## MUSTANG AERONAUTICS, INC.

Mustang II Service Letter

**Subject:** Canopy Frame Inspections

## Mustang II Canopy Frame Revision - 11/1/84

## A Cut and Butt Welded Cross Brace is NOT Acceptable

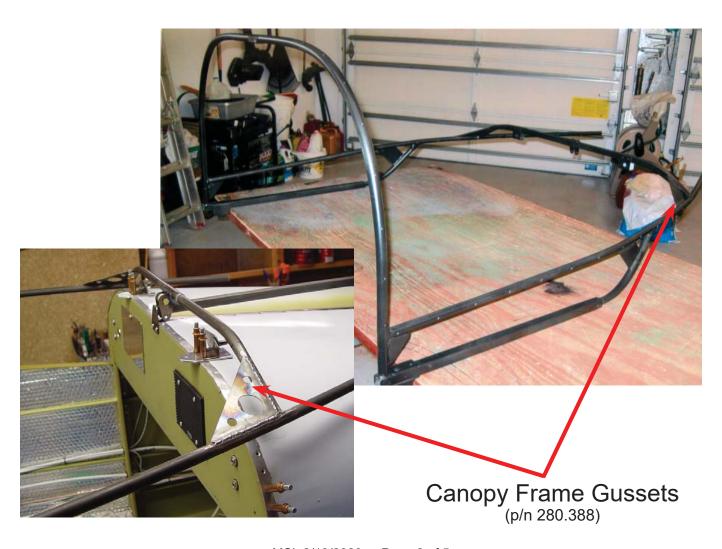
The rear cross brace p/n 280.350 should be formed in 1 piece per the plans and not made with a miter cut and butt welded as this would greatly weaken the part. Any such cut of the tube would need to be properly reinforced.
